Point Beach Nuclear Plant, Units 1 and 2  
Dockets 50-266 and 50-301  
Renewed License Nos. DPR-24 and DPR-27

License Amendment Request 261  
Extended Power Uprate  
Response to Request for Additional Information

#### LICENSE AMENDMENT REQUEST 261 EXTENDED POWER UPRATE RESPONSE TO REQUEST FOR ADDITIONAL INFORMATION

**FIGURES TO SUPPORT RESPONSE TO SBPB - AFW - RAI - 4**

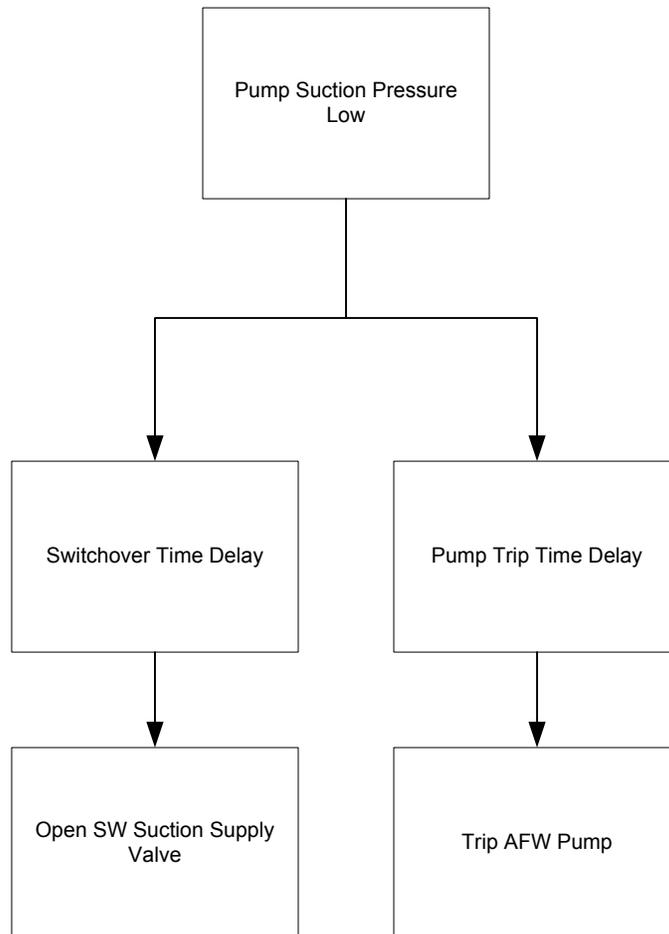
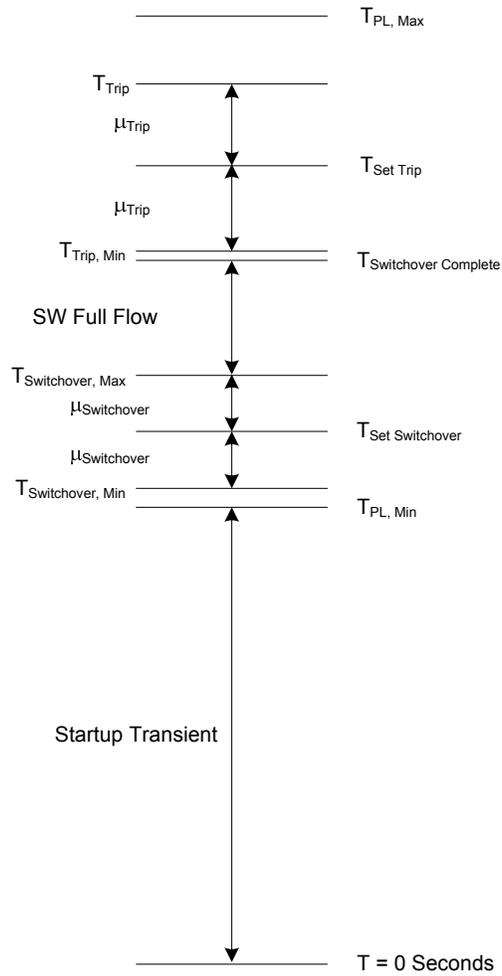
*The AFW pumps will be protected by a low pressure switch on the suction lines to each individual pump. However, there is time delay on the pump trip initiation. This same low pressure sensor also signals a swap-over from the condensate storage tank (CST) to the safety-related service water (SW) supply. The license allows sufficient time for the swap-over to occur, and if suction pressure is not restored, the AFW pump is tripped. In the event the nonsafety-related portion of the suction line is lost, the remaining section of protected piping needs to have sufficient supply of water to protect the pumps from damage and tripping prior to swapping over to SW.*

*Provide details on how the logics and timing was developed for the low pressure swap-over and trip circuitry to avoid tripping the AFW pumps while still protecting the pumps from loss of suction supply, to include showing the protected piping has sufficient volume for the swap-over to occur, or trip the pump prior to damage from loss of supply.*

The logic and timing of the low suction pressure suction switchover design for the TDAFW and MDAFW pumps is described below.

1. The volume of the protected portion of the pump suction piping is determined by review of the physical layout of the suction piping.
2. The water consumption is determined for two scenarios; pump startup coincident with the loss of suction supply and loss of suction supply with pumps in operation.
3. The low suction pressure signal initiates two time delay relays.

4. The first time delay relay initiates opening of the SW suction supply valve. This time delay is set long enough to avoid spurious operation of the SW suction supply valve during normal pump startup transients.
5. The second time delay initiates trip of the affected AFW pump if the transfer to the SW suction supply is not effective in raising the suction pressure above the low suction pressure trip setpoint. This time delay is set long enough to allow the SW suction supply valve to open far enough to meet the water consumption requirements of the AFW pump. The maximum delay setting ensures that the pump trips prior to the suction supply being consumed.

Figures 1 and 2 in Enclosure 2 provide a diagram of the suction switchover and pump trip logic and the approach used in establishing the suction pressure time delays.

## Doc./Curve No. 280- RLCA02997-01

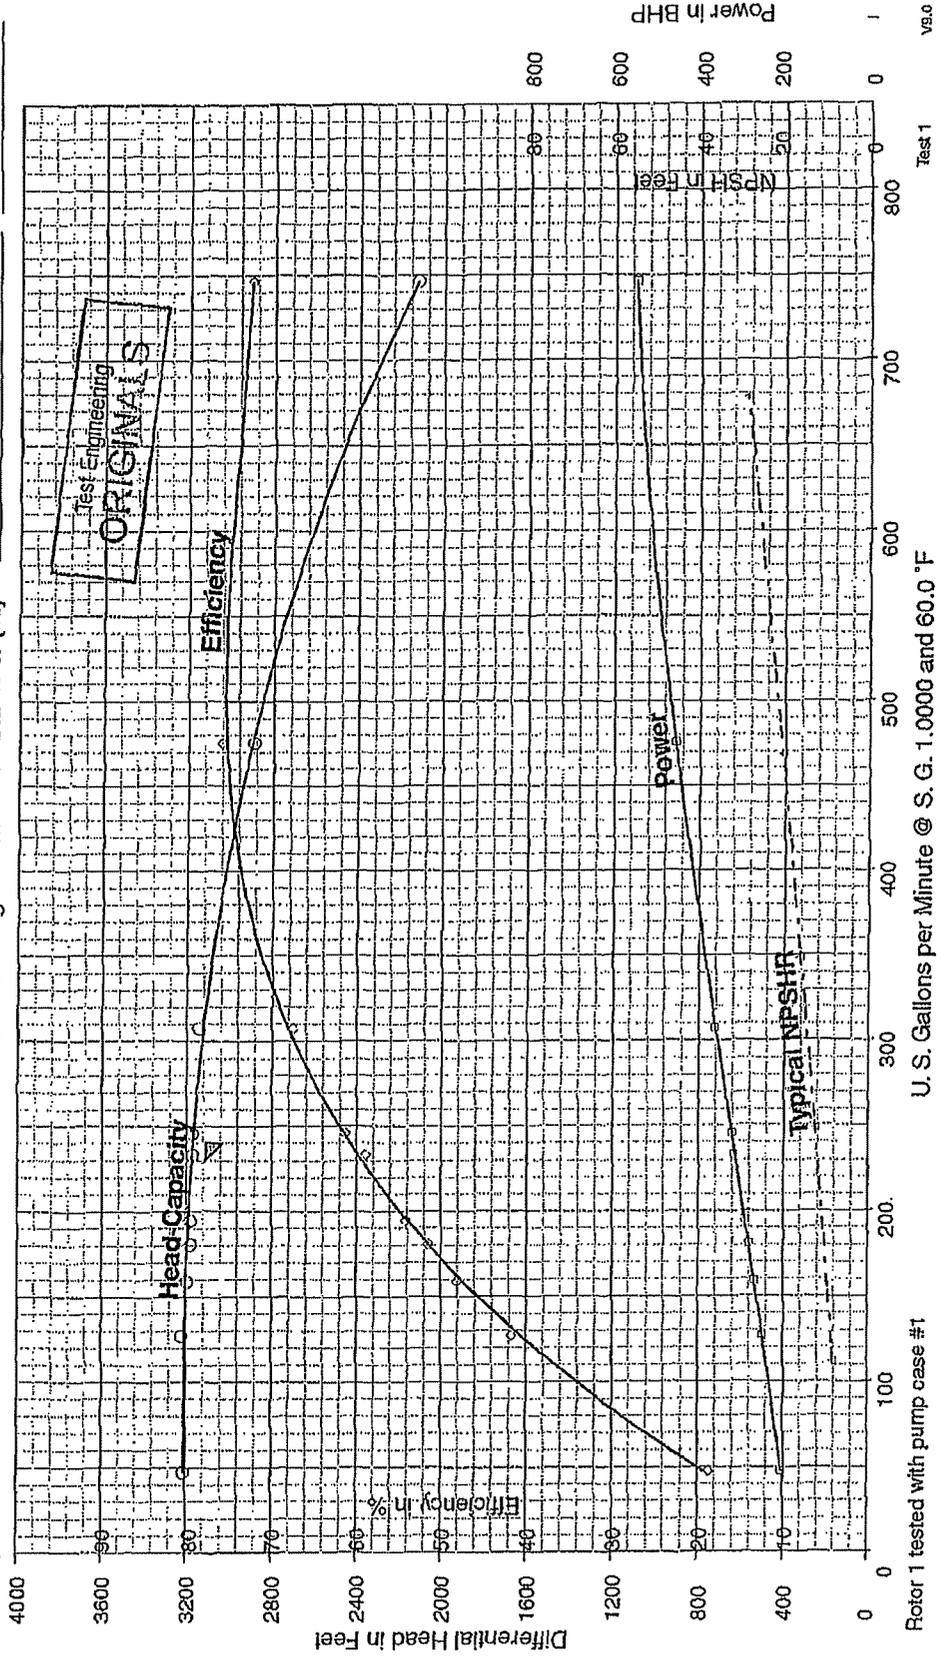
*The design flow requirement for the new MDAFW pump is 285 gpm at 3050 ft to meet the design basis for AFW.*

*Provide the pump curves to show that the new MDAFW pump can meet this requirement.*

Pump curves for the new MDAFW pumps are provided in Enclosure 3.
